Previously Approved Site Plan (1/2/2020)
Currently Proposed Site Plan (3/12/2020)

Project: PROPOSED DISTRIBUTION FACILITY PROJECT
SECTION 81.07(a), 8.1 & 9.2
TOWN OF CLAY
ONONDAGA COUNTY NEW YORK

Drawing Title: **OVERALL SITE PLAN**

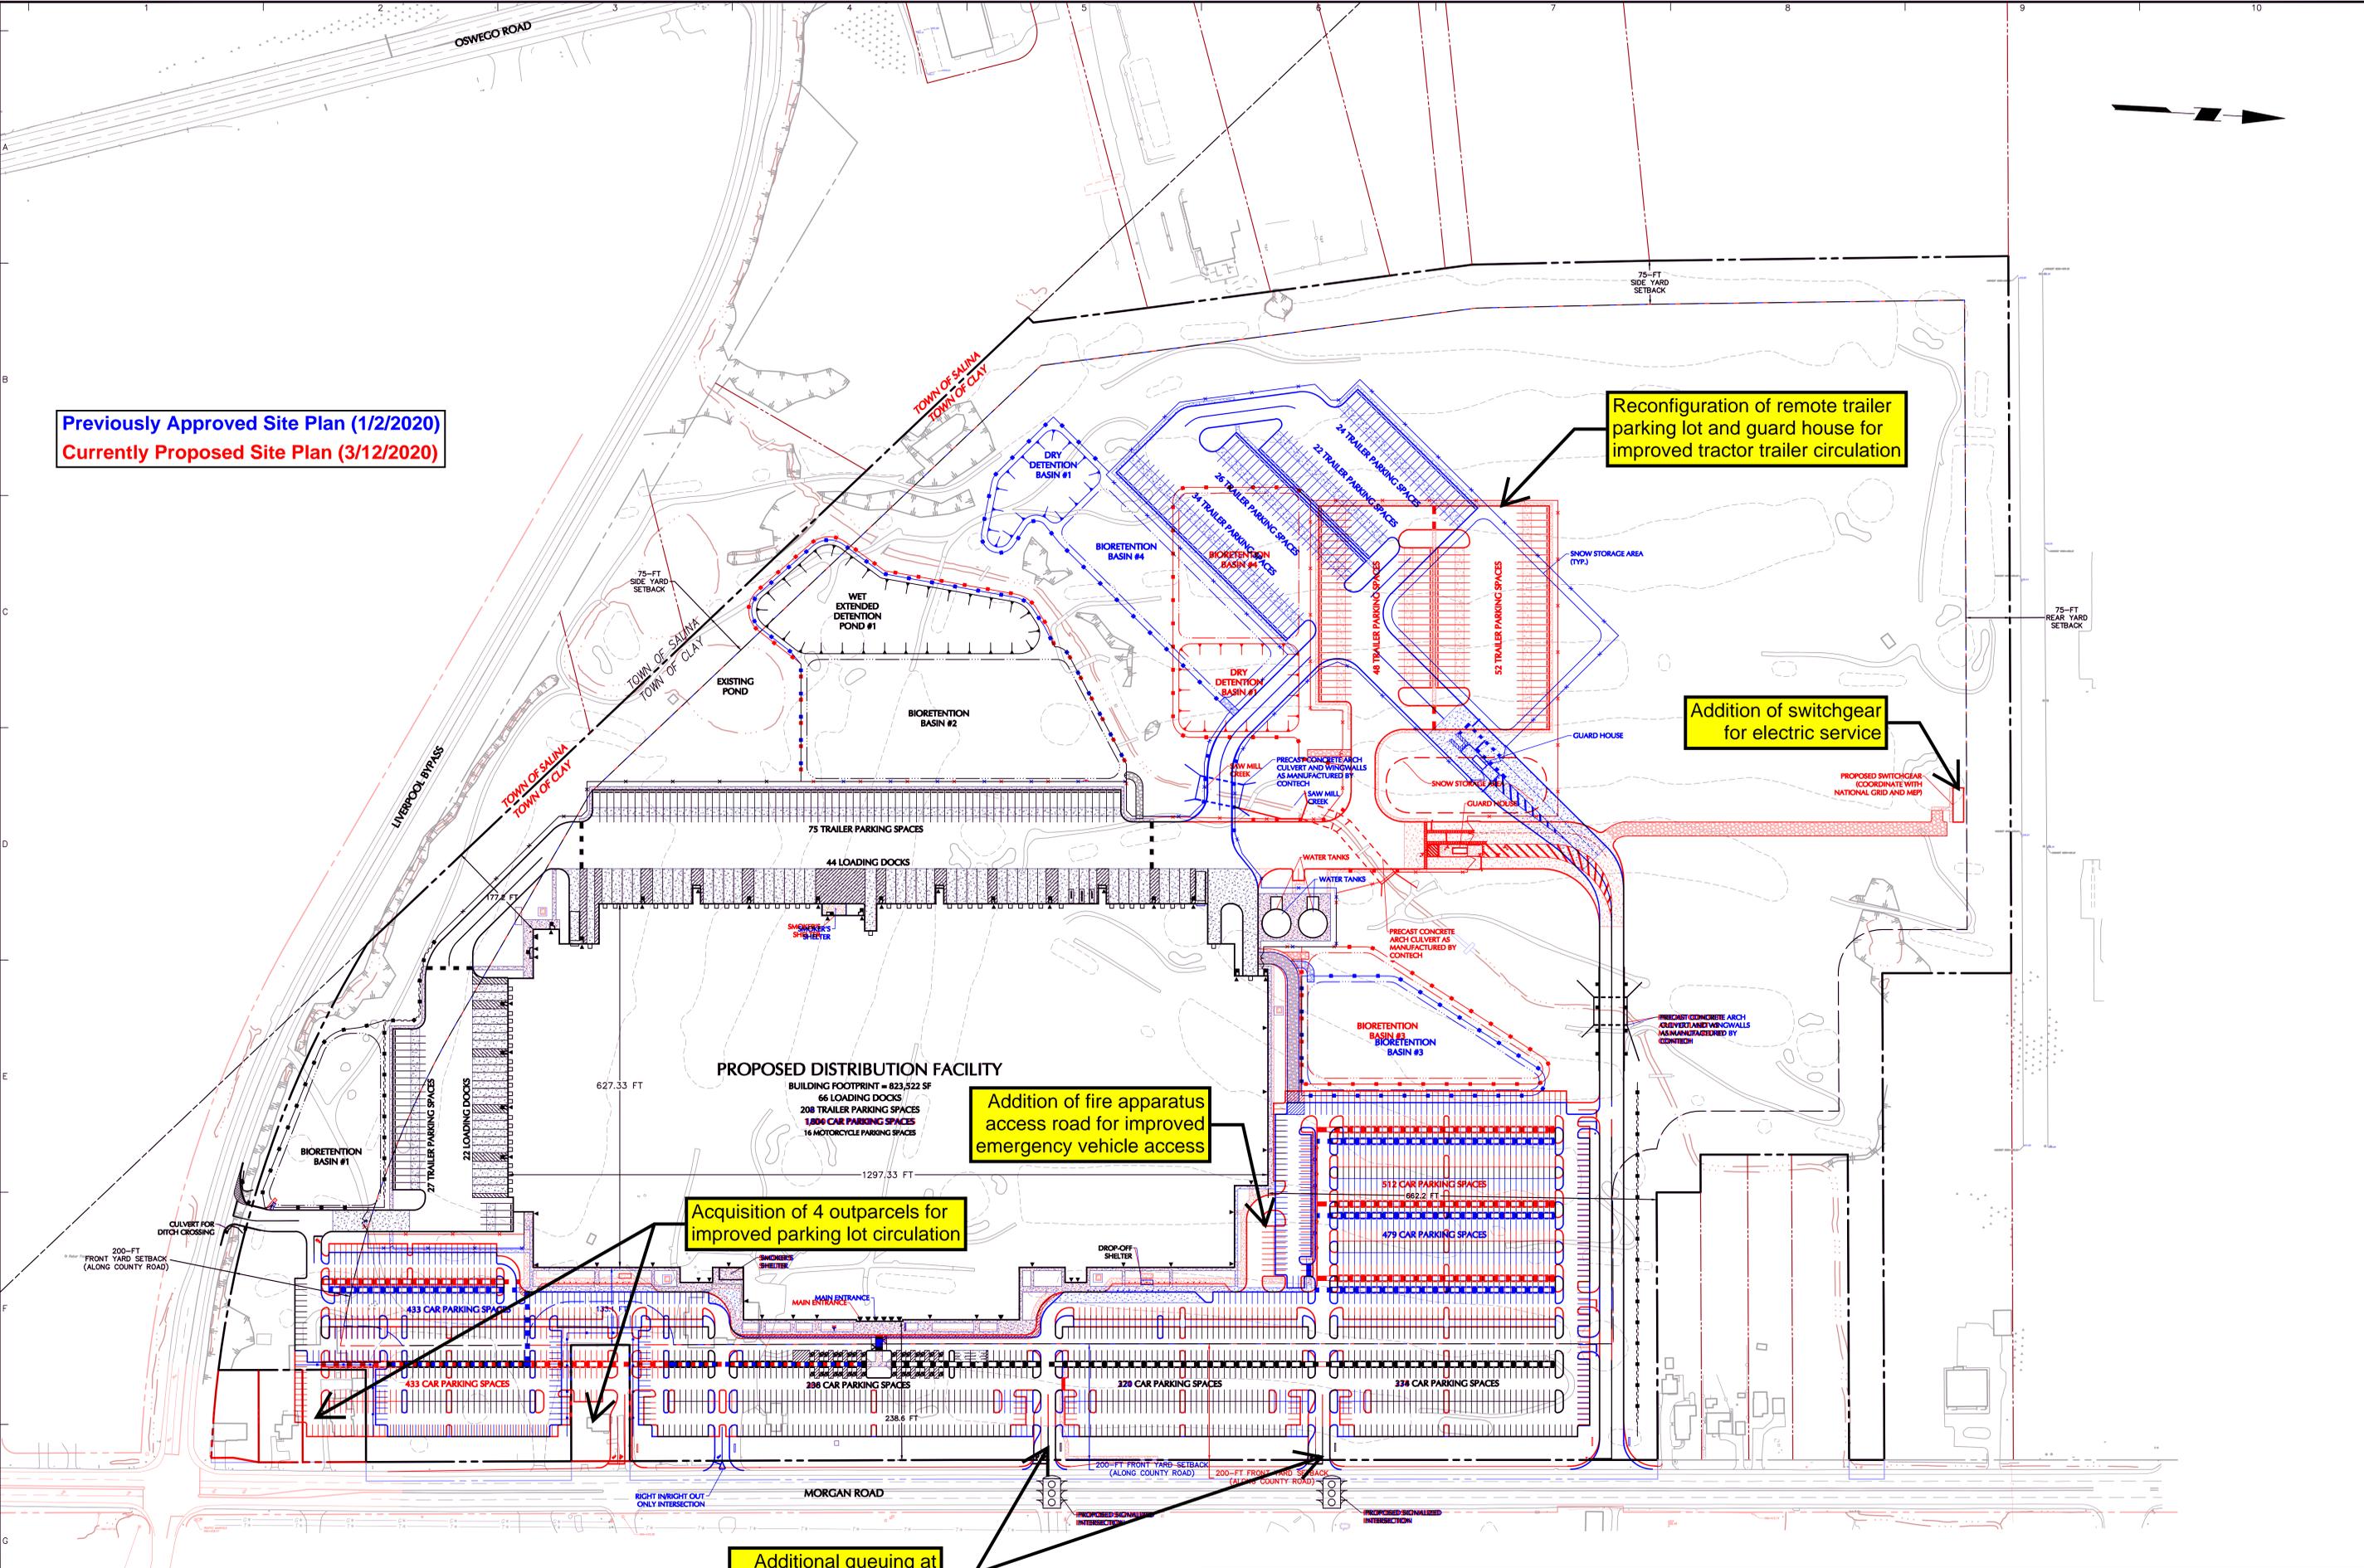
Reconfiguration of remote trailer parking lot and guard house for improved tractor trailer circulation

Addition of switchgear for electric service

Addition of fire apparatus access road for improved emergency vehicle access

Acquisition of 4 outparcels for improved parking lot circulation

Additional queuing at signalized intersections
